Nafa Apparels Ltd. 2 (Extension)

10 September 2024

Six Storied New RCC Building-1: six storied RC structure with a basement (B+G+5).

Column C-2 & C-3 rebar scan

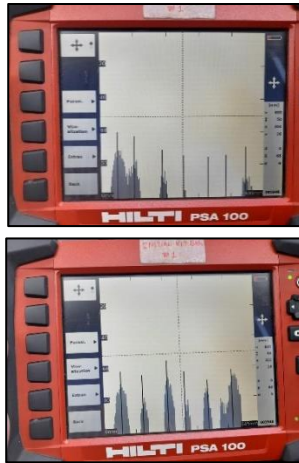
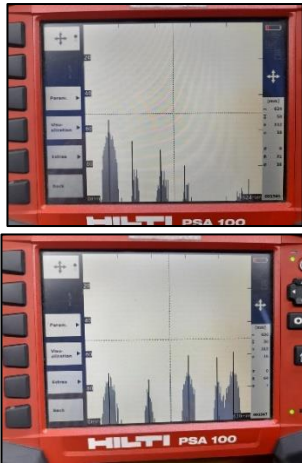
Observation-2: Discrepancies in as-built drawings. (Six Storied New RCC Building-1)

Description: The number of rebars in the C2 columns found 20 instead of 24 and the amount of rebar in the C3 column found 18 instead of 20. The building engineer is required to survey the whole structure and prepare a full set of as-built drawings.

2.	Discrepancies in as-built drawings. (Six Storied New RCC Building-1)	The building engineer is required to survey the whole structure and prepare a full set of as-built drawings.	within 6 weeks

Column Schedule

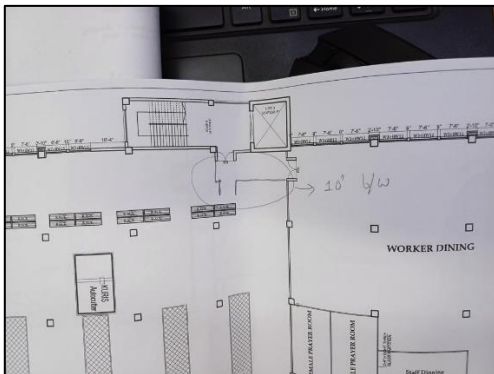
Description: In the marked location on the 4th floor 250 mm brick wall was found on site. But in the as-built drawing, no brick layout was mentioned. The building engineer is required to survey the whole structure and prepare a full set of as-built drawings with brick wall legends.

Observation-5: Water intrusion in the basement RC wall. (Six Storied New RCC Building-1)

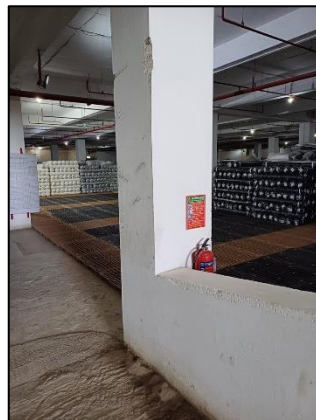
Description: During the inspection, water intrusion was found on the basement RC wall. The building engineer is required to seal the crack/leakage of the RC wall to stop water intrusion and repair it with suitable methods.

5.	Water intrusion in the basement RC wall. (Six Storied New RCC Building-1)	The building engineer is required to seal the water intrusion and repair it using a suitable method.	within 6 weeks

Observation-7: Column susceptible to vehicle impact. (Six Storied New RCC Building-1)

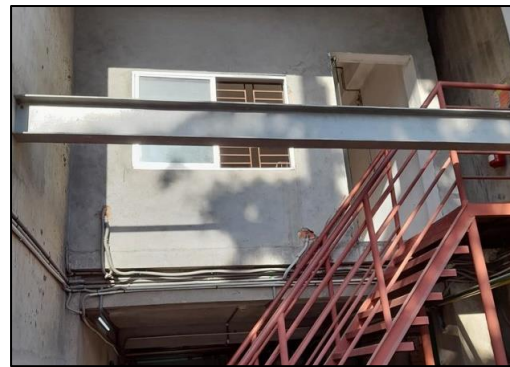
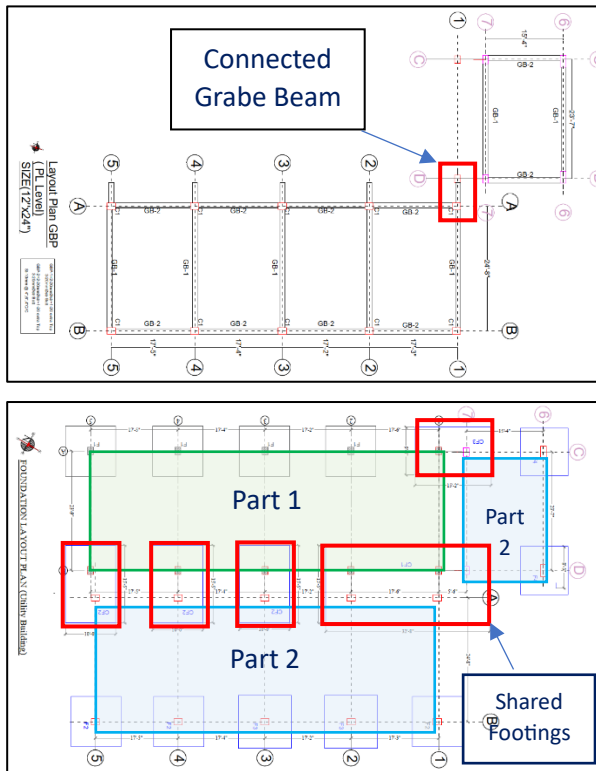
Description: RC columns on the ground floor & basement were susceptible to vehicle impact. The building engineer is required to provide a barrier around the column to avoid vehicle impact.

7.	Column susceptible to vehicle impact. (Six Storied New RCC Building-1)	The building engineer is required to provide a barrier around the column to avoid vehicle impact.	within 6 months

Observation-8: Lack of structural assessment report. (Utility Building Part 1 & 2)

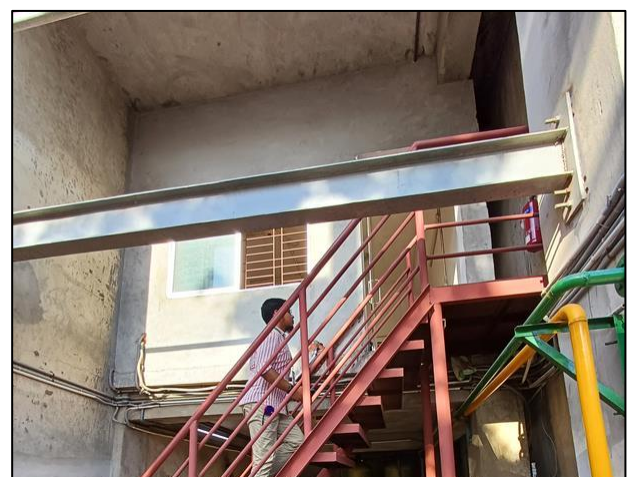
Description: The Utility building consists of three parts- Part 1, Part 2, and Part 3. Part 1 is a partially two-storied. The partial upper story is a steel shed. There is a self-supported RC mezzanine on the ground floor of Part 1. The upper steel story was constructed after retrofitting the ground floor columns. Part 2 is a single-storied RC structure. Part-1 and Part-2 are structurally connected with footing and grade beam which were connected during retrofitting construction. The building engineer is required to prepare an Engineering Assessment (EA) of the utility building and submit the required documents to the RSC for review.

8.	Lack of structural assessment report. (Utility Building Part 1 & 2)	The building engineer is required to prepare the EA of the utility building and submit it to RSC for review.	within 6 weeks
		Carry out suggested remedial works if required.	within 6 months

Observation-10: Missing load plan of the mezzanine floor and EGB Boiler. (Utility Building Part 1)

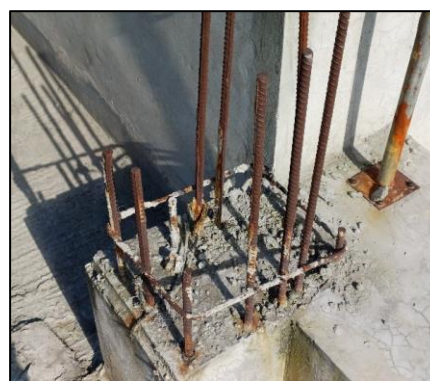
Description: The load plan of the self-supported mezzanine floor at Utility Part 1 ground floor was missing. Also, the Load plan of the EGB Boiler at the roof of Utility Part 1 was missing. The building engineer is required to prepare the load plan and maintain floor loading accordingly.

10.	Missing load plan of the mezzanine floor and EGB Boiler. (Utility Building Part 1)	The building engineer is required to prepare the load plan and maintain loading accordingly.	within 6 weeks
